**AGENDA**  
**OURAY COUNTY VISUAL IMPACT REVIEW COMMITTEE**  
**REGULAR MEETING**

Project: Application for Variance from Section 9  
Address: Lot 2, Eagle Hill Ranch, Filing #1  
Owner: Belinda and Tim Chisholm

**LAND USE DEPARTMENT**  
**STAFF REPORT - ADDENDUM**  
**September 30, 2020**

**Variance Request- Section 9 (continued hearing- updated narrative)**

**Chisholm- Site Plan relocated house**

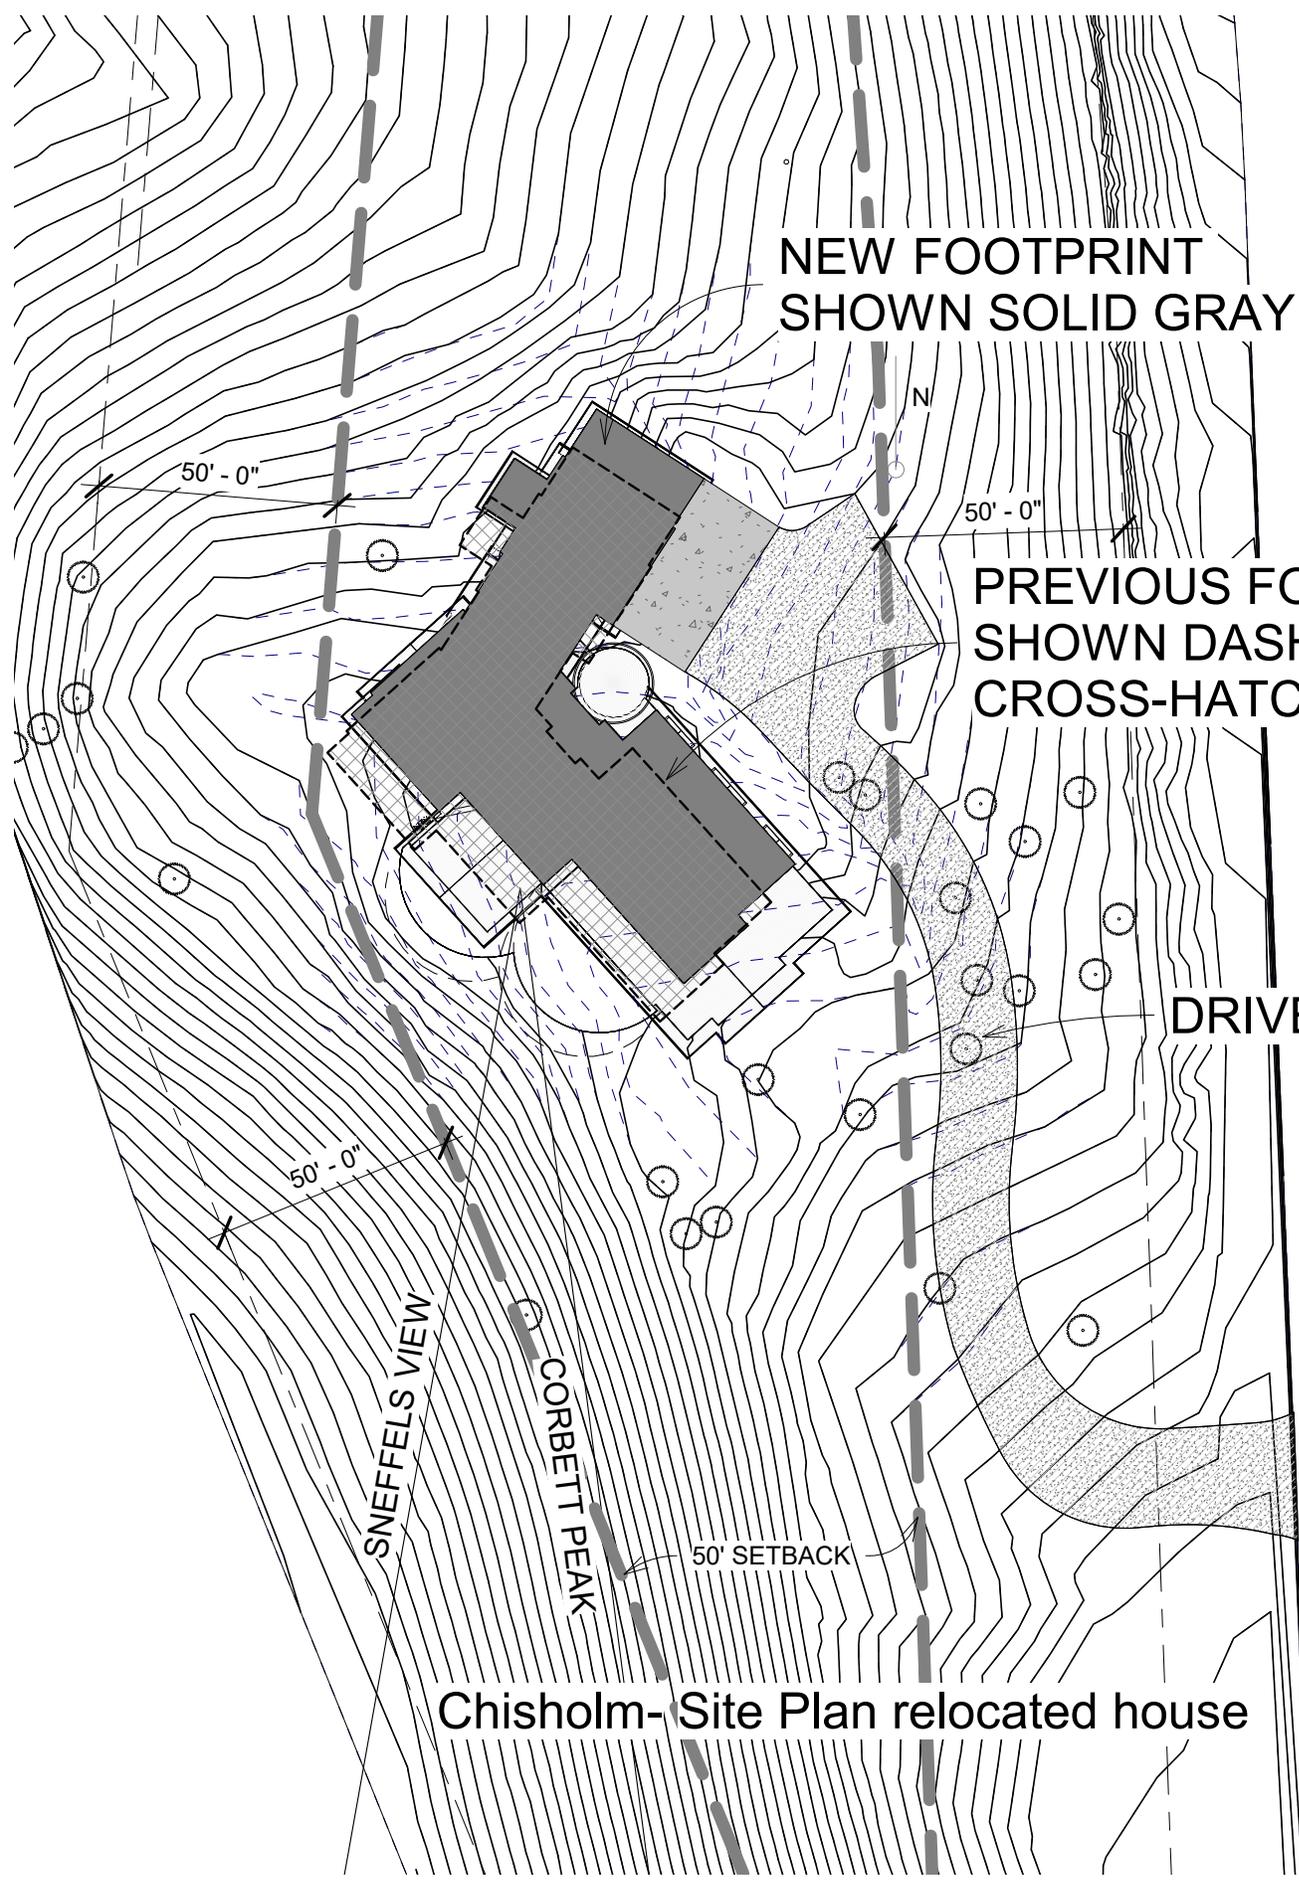
After receiving input at the 9-9-20 VIRC hearing requesting we look at possibilities for a reduction in amount of skyline breakage we made a combination of changes which we feel makes a major impact. We lowered the roof pitches from 8/12 to 6/12, dropped the floor level 1 foot and moved the house 8 feet north and 5 feet east.

After looking at various possibilities the house has been moved to east and north far enough to have a significant impact on visibility, but moving farther to east pinches driveway further and would require removal of additional trees and more disturbance for grading. Moving farther to north the grade continues to drop away more quickly into the drainage path and creates grading issues.

NEW FOOTPRINT  
SHOWN SOLID GRAY

PREVIOUS FOOTPRINT  
SHOWN DASHED,  
CROSS-HATCHED
